Service Note		
Product	Description:	Service note no.
M5000	Modification to avoid E04 when warm	71210T057

This modification concerns only M5000s with serial no. **between 280000 and 281720**.

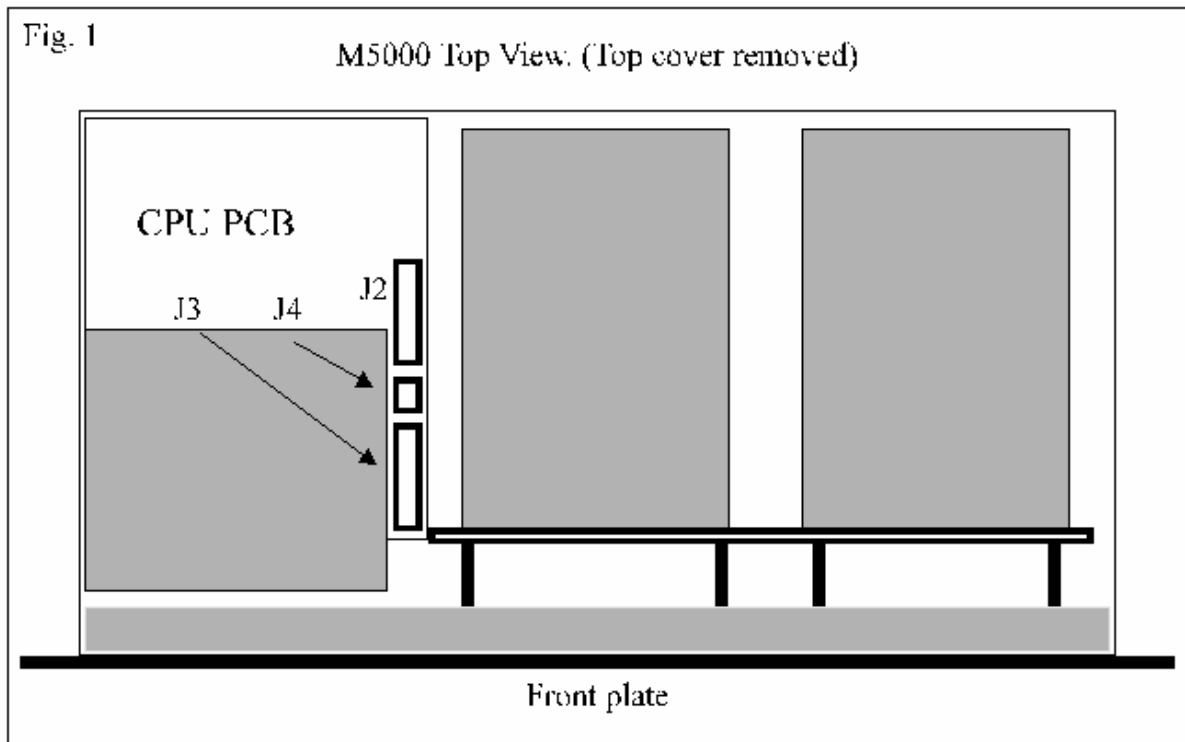
1. Disconnect power
2. Remove the top cover and the bottom cover.
3. Remove the 3 cables to the CPU-PCB. The 3 cables are connected to J2, J3 and J4. See fig. 1.

Fig. 2

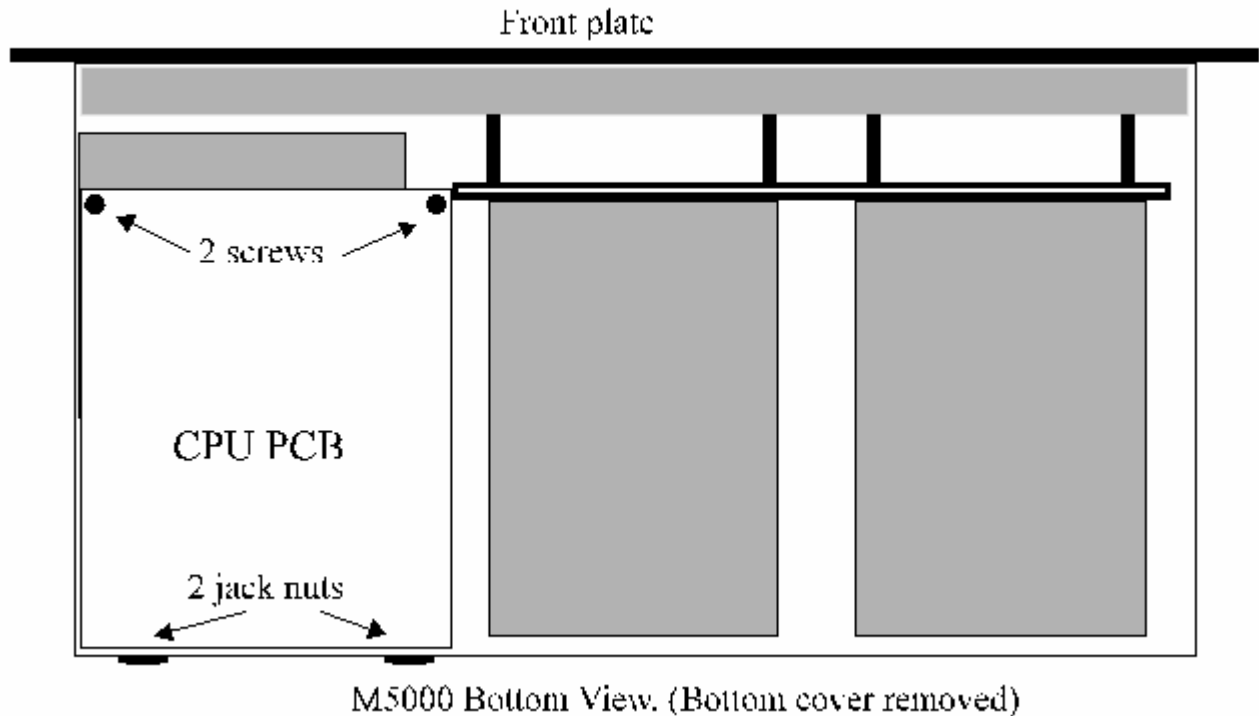
4. Remove the CPU PCB by unscrewing 2 screws on the solder side of the PCB and by unscrewing the 2 jack nuts. See fig. 2.

Fig. 3:

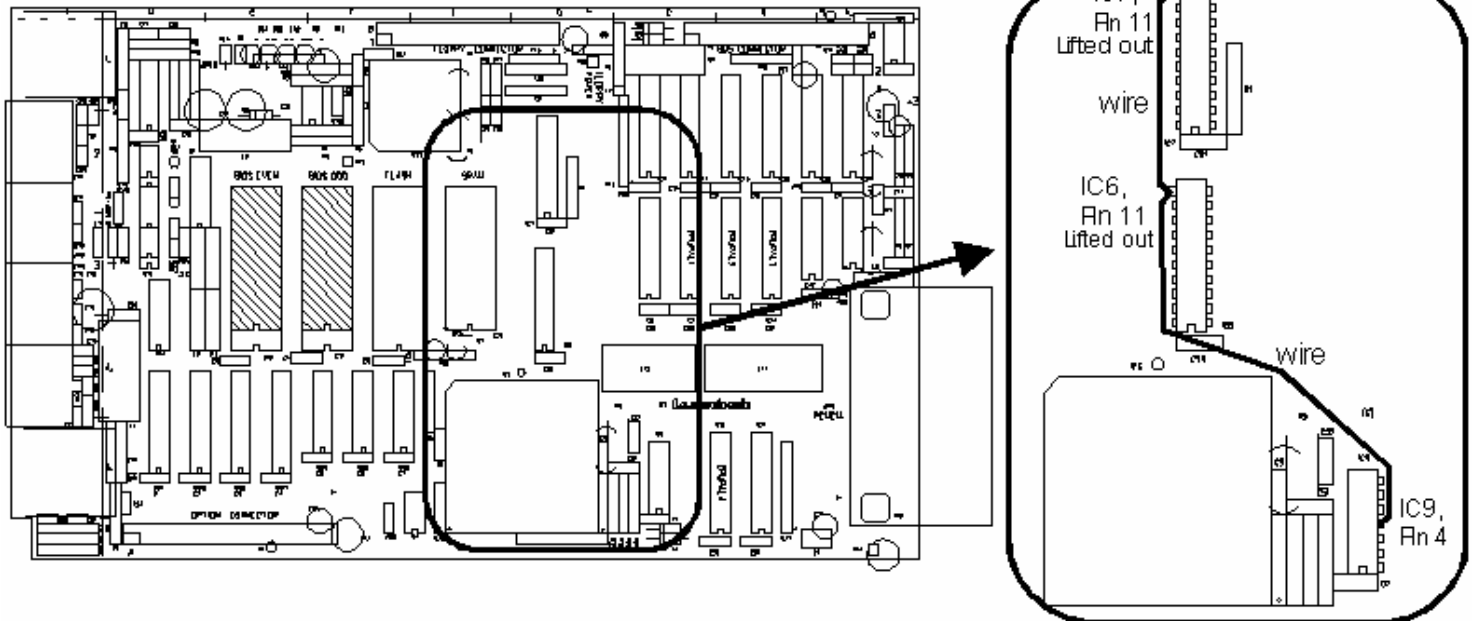
- Lift out (carefully) pin 11 at the two chips called IC6 and IC7 on the CPU PCB. See fig. 3.

- Solder a wire from IC6 pin 11 (lifted out) to IC9 pin 4.

7. Solder a wire from IC6 pin 11 (lifted out) to IC7 pin 11 (lifted out).
8. Mount the CPU PCB again with the 2 screws and the 2 jack nuts.
9. Mount the 3 cables again.
10. Mount top and bottom cover.

After this modification the signal called AS* is no longer connected to IC6 and IC7.

Instead the signal called RAS* is connected to IC6 and IC7.
